<b>AMENDMENT OF SOLICITATION/MODIFICATION OF CONTRACT</b>			1. CONTRACT ID CODE N/A	PAGE 1 OF 21 PAGES
2. AMENDMENT/MODIFICATION NO. 0005	3. EFFECTIVE DATE MAR. 14, 2002	4. REQUISITION/PURCHASE REQ. NO. N/A	5. PROJECT NO. (If applicable) SPEC. NO. 1249	
6. ISSUED BY DEPARTMENT OF THE ARMY U.S. ARMY ENGINEER DISTRICT, SACRAMENTO SACRAMENTO, CALIFORNIA 95814-2922	CODE	7. ADMINISTERED BY (If other than Item 6) DISTRICT ENGINEER U.S. ARMY ENGINEER DISTRICT, SACRAMENTO 1325 J STREET SACRAMENTO, CALIFORNIA 95814-2922 ATTN: CONTRACTING DIVISION	CODE

FY02 REPLACEMENT ARMY FAMILY HOUSING  
WNR PP WEST/P1 (72 UNITS)  
Fort Huachuca, Arizona

1. Revised Pages: Frontend Pages (1,2,8,26,27,28,31,36,37 of 230),01010-2, 01010-3,01010-14, 01010-15, 1010-19, 01010-20, 01010-21, 01010-22, 01011-30
2. Revised Drawings: Master Plan Concept, Family Housing Site Layout "B"

EXISTING HOUSING SITE LAYOUT FOR  
MASTER PLAN CONCEPT  
PERSHING PLAZA/MILES MANOR

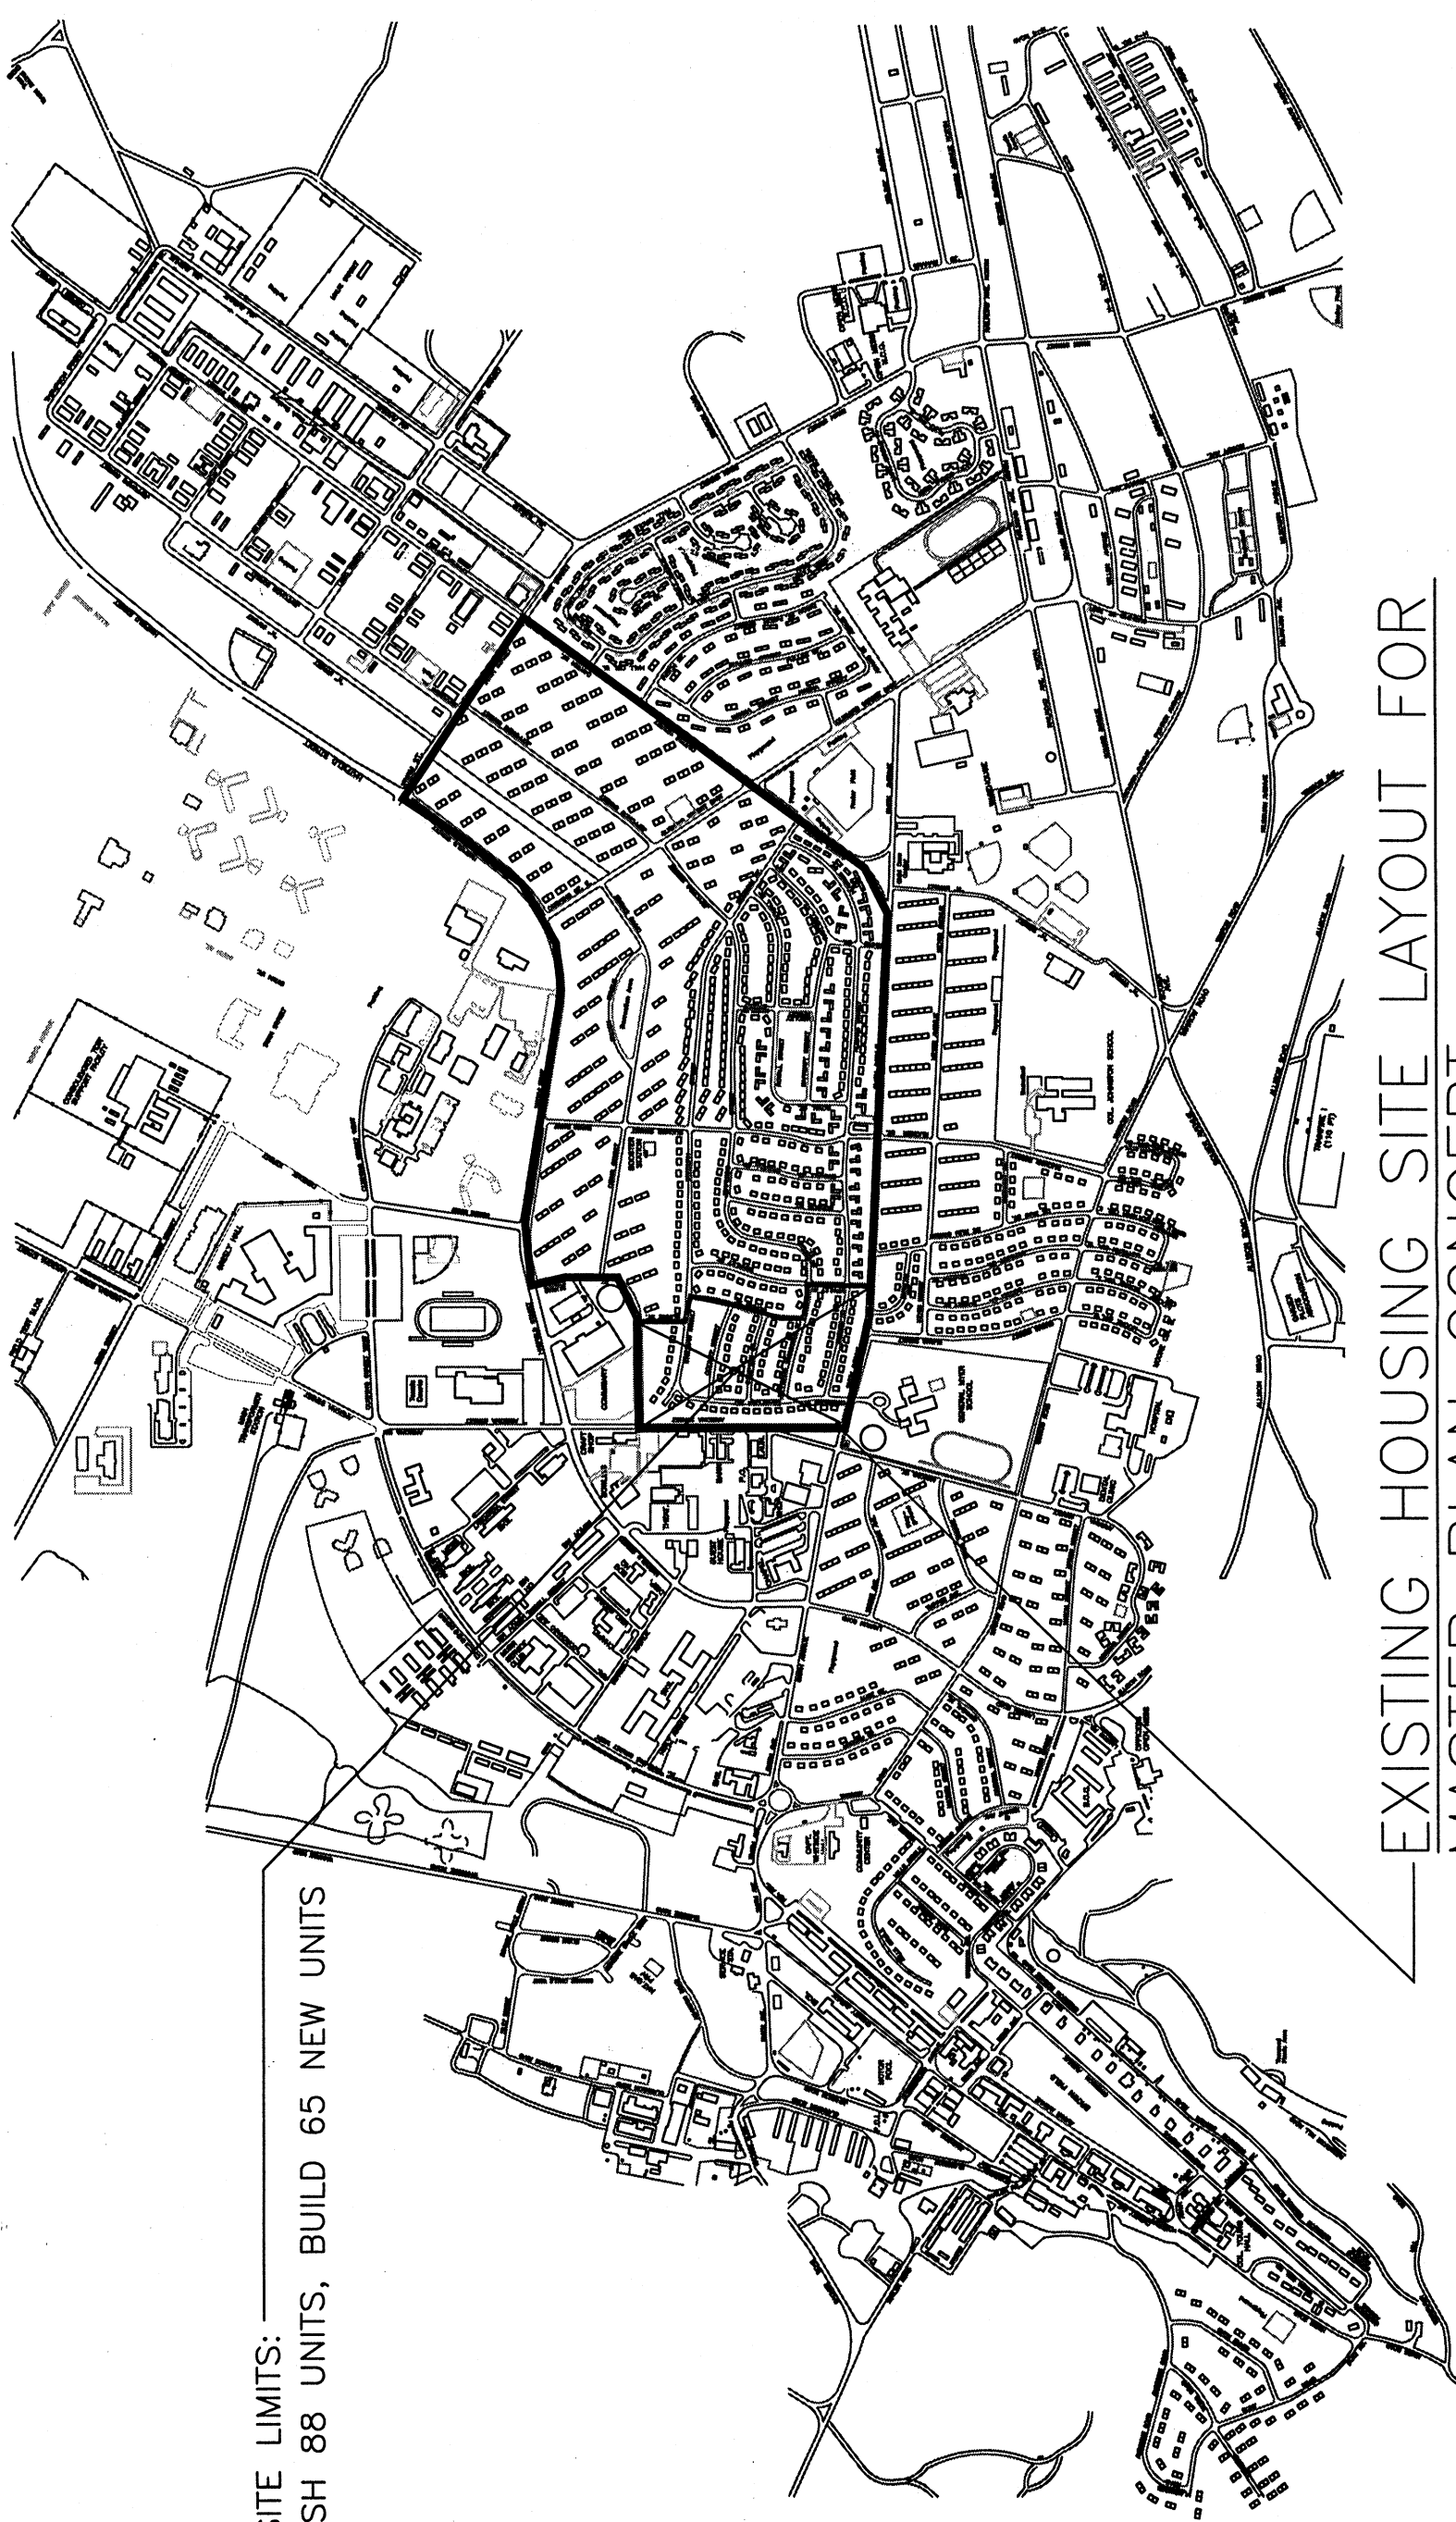
1.a.(3).(a). Site area. The site is described on the RFP drawings that are included as part of this solicitation, called the Pershing Plaza West site. **See the drawing titled "Existing Housing Site Layout For Master Plan Concept Pershing Plaza/Miles Manor". The eight family housing units north of Stedman St. and west of Burns St. are to also be demolished and this land can be used for new housing units even though topographic survey is not being provided for this area. The existing playground south of Stedman St. and west of Burns St. can also be used for new housing units.** Site work includes all design and construction of the site design to include grading, storm drainage, erosion control, pedestrian and vehicular circulation, utility systems, outdoor lighting, play lots, neighborhood parks, and physical security. **See paragraph 3.b. for Conceptual Master Plan for entire Pershing Plaza and Miles Manor, the conceptual, visionary design that is also part of the work.**

FY02 SITE LIMITS:  
DEMOLISH 88 UNITS, BUILD 65 NEW UNITS

**FAMILY HOUSING SITE LAYOUT 'B'**

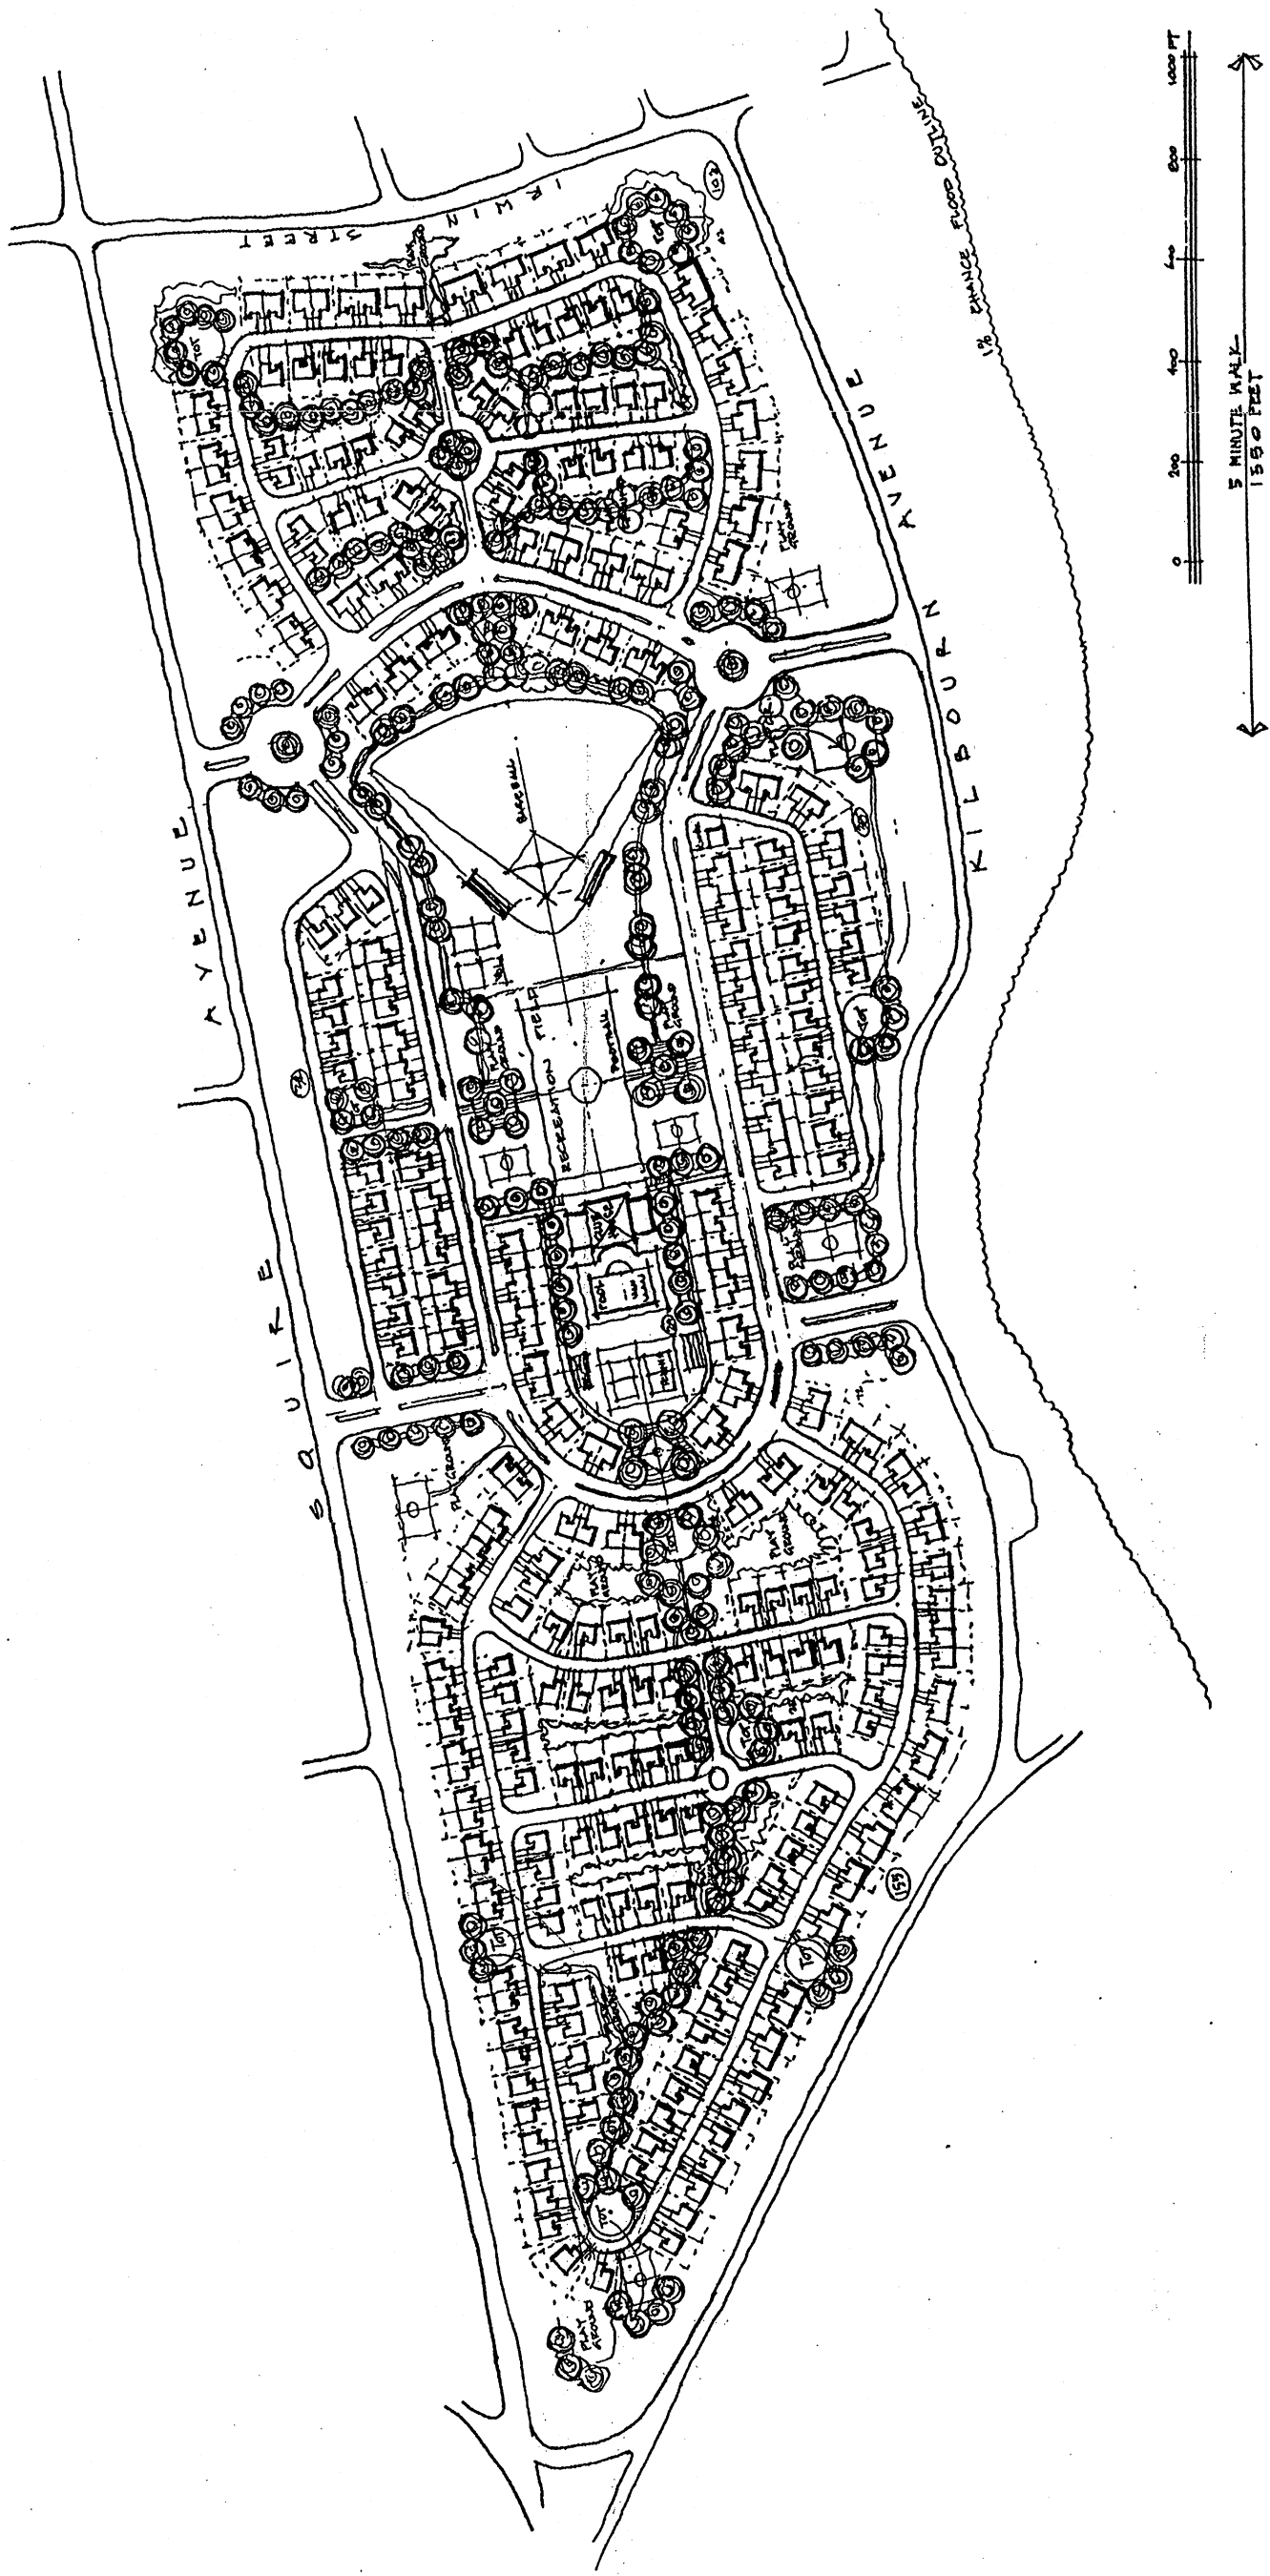
*An example of what is required is shown on the attached drawing labeled "Family Housing Site Layout "B".*

*The desirable aspects of this drawing are:*

- Clusters of housing units.
- Walking/jogging paths throughout the development.
- Well-placed tot lots.
- Variety of street forms that mostly avoid the parallel grid-like forms of the present FY03 site.
- Limited number of through-streets running north-south (suggested streets that may continue to run north-south are Stanley/Burns (already part of the requirements of the present FY02 project), Ruckers St., and Cushing Street East; these last two need not continue a straight lines but their entry/exit to/from the development are spaced about what would be expected. No housing units should face or enter directly onto the streets surrounding the development: Hatfield St., Irwin St., Carter St., Smith Ave., Arizona St., and that part of Burns St. on the perimeter.
- Club house/community building, tennis courts, basketball court, volleyball court, recreation field including baseball field

*The undesirable aspects of this drawing are:*

- Swimming pool: there will be no swimming pool.
- Housing density: prefer about 20% less dense than shown on the drawing.
- Repetitive housing types: prefer greater mix of different housing types with variation in setbacks and with less back-to-back units.
- Perimeter housing units: prefer less perimeter units.
